UNITED STATES PATENT AND TRADEMARK OFFICE

| APPLICATION NO. | FILING DATE | FIRST NAMED INVENTOR | ATTORNEY DOCKET NO. | CONFIRMATION NO. |
|-----------------|-------------|----------------------|---------------------|------------------|
| 09/935,151 | 08/22/2001 | Gregory Alan Steube | 20518/13 (S-8475) | 9252 |

Office Action Summary

DETAILED ACTION

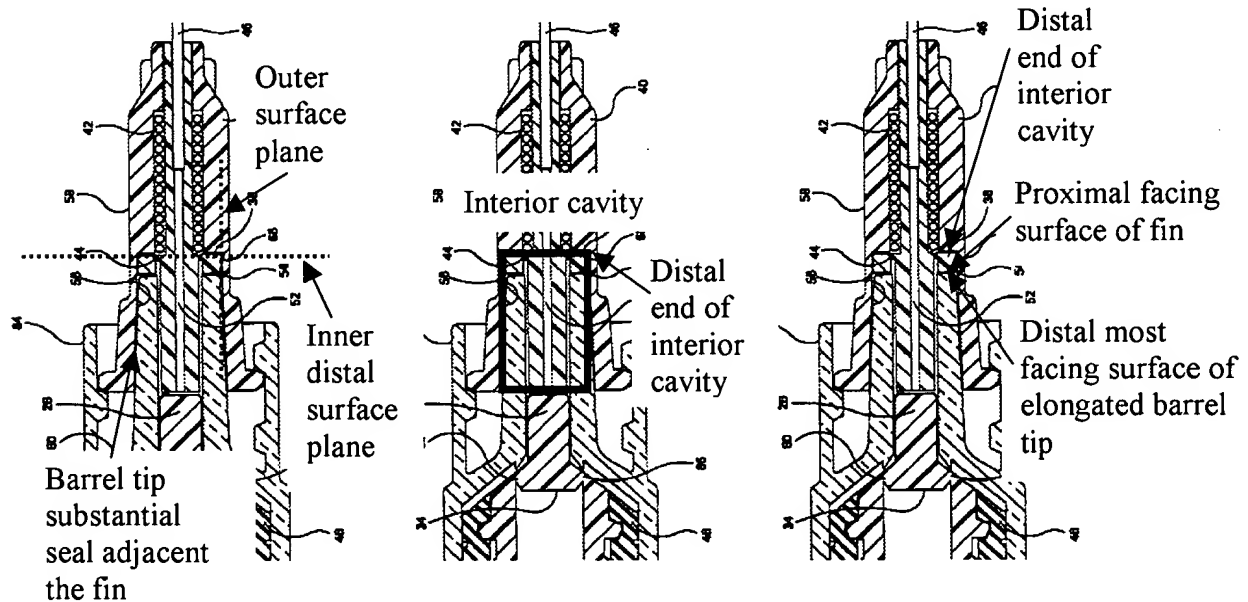
Claims 1-7, 10-18 and 21-26 are rejected under 35 U.S.C. 102(b) as being anticipated by Carter et al (USPN 6,010,486). Regarding claims 1, 5 and 21, Carter discloses a needle assembly that includes a needle hub (40) defining an interior cavity (see middle figure below), a distal end (see middle figure below), and one non-sealing rigid fin (54) having an outer surface plane that intersects an interior surface plane of the needle hub (see left figure below) that defines the

interior cavity. The fin is considered rigid because the cross hatchings for the fin used in figure 6 indicate that the material used is plastic. In order for any type of plastic material to maintain the shape of the fin shown in figure 6, the property of the plastic material used would necessarily have to include some degree of rigidity. The fin is considered non-sealing in that the prior art specification does not reference the element (54) as a gasket, o-ring or seal. The fin extends longitudinally a fixed distance from the distal end of the interior cavity to a proximal facing surface (see right figure below). The proximal facing surface engages a distal most facing surface of an elongated barrel tip (see right figure below). The needle hub also includes a needle support (tubular portion of 38 not including fin) which extends through the interior cavity. A barrel (20) has a proximal end and a distal end with the barrel tip at the distal end which is received within the interior cavity. See figure 2 and middle figure below.

Regarding claims 2-4 and 22, the barrel tip is elongated and extends from the distal end of the barrel (see figures above). The interior cavity has an annular configuration, see figure 2 in conjunction with figure 6. The barrel tip forms a substantial seal adjacent the fin in that the outer

surface of the barrel tip is fastened to the interior surface (56) of the needle hub (40). See above figures. Additionally, even though the prior art does not specify that the fastening of the needle hub to the barrel tip forms a seal, the claim language only recites a substantial seal and to seal is defined as “to close or make secure against access, leakage, or passage by a fastening or coating” (see <http://www.merriam-webster.com/cgi-bin/dictionary>). In this case, the connection of the needle hub (40) to the barrel tip closes off access to the barrel tip by the fastening or connection of the two elements and thereby reads on the limitation of a “substantial seal”.

Regarding claims 10-17 and 23-26, the needle hub (40) includes a hub skirt (see flange on proximal end of needle hub (4) in figure 6). The interior cavity (see above middle figure) is annularly defined between the perimeter of the hub skirt and the interior axis of the needle support (38). The needle support (38) has a needle cavity (52) having a portion of the needle disposed therein. See figure 6. As shown in figure 6, the needle cavity and interior cavity are coaxial. Since the cavities are coaxial, they are also substantially parallel since they extend in the same longitudinal direction. As shown in figures 6-7, the barrel receives a plunger (30) that is configured to engage a proximal opening of the needle support (38).
